Office Action Summary

09/889,788

KOBAYASHI ET AL.

DETAILED ACTION

FIG. 1(a)

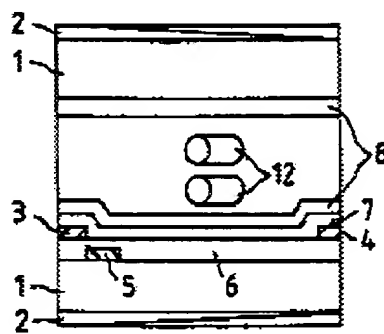
As to claims 1, 7, 9, and 14-15, Ohe discloses in Figures 1-6, a liquid crystal display device comprising a pair of substrates and a liquid crystal layer held between the pair of substrates (Summary of the Invention, col. 1, line 53 through col. 4, line 7), at least one of the pair of substrates being provided with plural electrodes, 3 & 4, for applying a lateral electric field to the liquid crystal layer (col. 1, lines 64 and 65); an

insulating film, 7 (Applicant's protection films), wherein the film thickness of the protecting film is in the range of $0.4\text{ }\mu\text{m}$ to $2\text{ }\mu\text{m}$ (col. 3, lines 42-44), and oriented films, 8, formed on both of the pair of substrates (col. 1, lines 66 and 67); wherein no visible residual image remains (col. 1, lines 54-58 and col. 9, lines 42-54) (Applicant's an AC residual image of the oriented films is less than 8%).

The invention of Ohe deals primarily with the improved insulating and alignment layers to reduce residual image, and the values of Ohe overlap the claimed ranges.

Ohe does not explicitly disclose an AC residual image which occurs even in a case of driving by pure AC that is less than 8%.

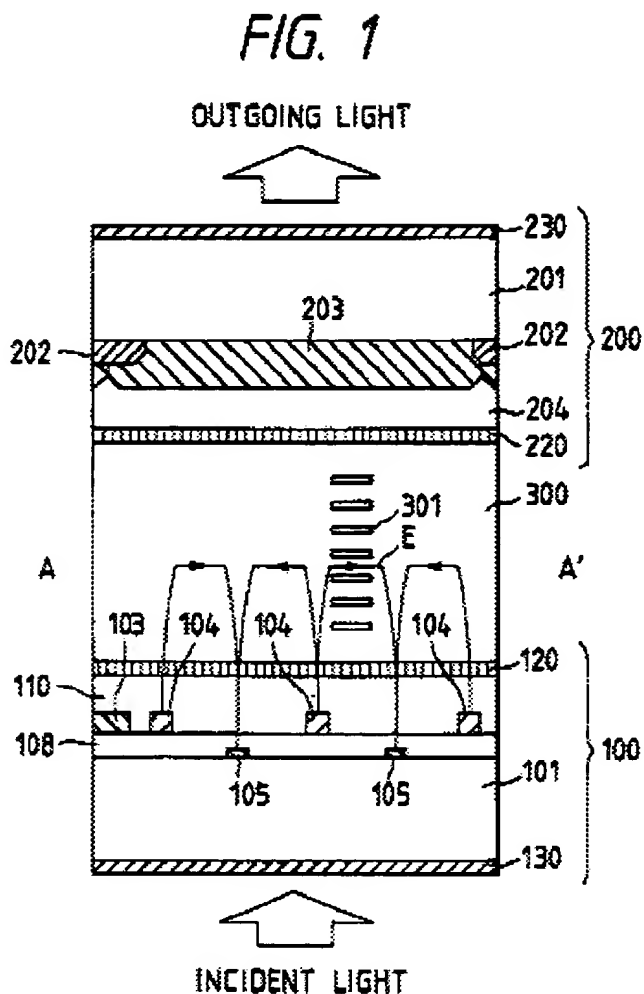
Ota teaches that in an in-plane switch LCD the use of AC driving (Applicant's driving by pure AC) reduces the residual image relative direct current operation (col. 9, lines 54-65) to achieve a display having preferable quality. Note that Ota confirms the AC residual image would be less than the DC residual image that has already been made virtually zero by Ohe, therefore well within Applicant's range of less than 8%.
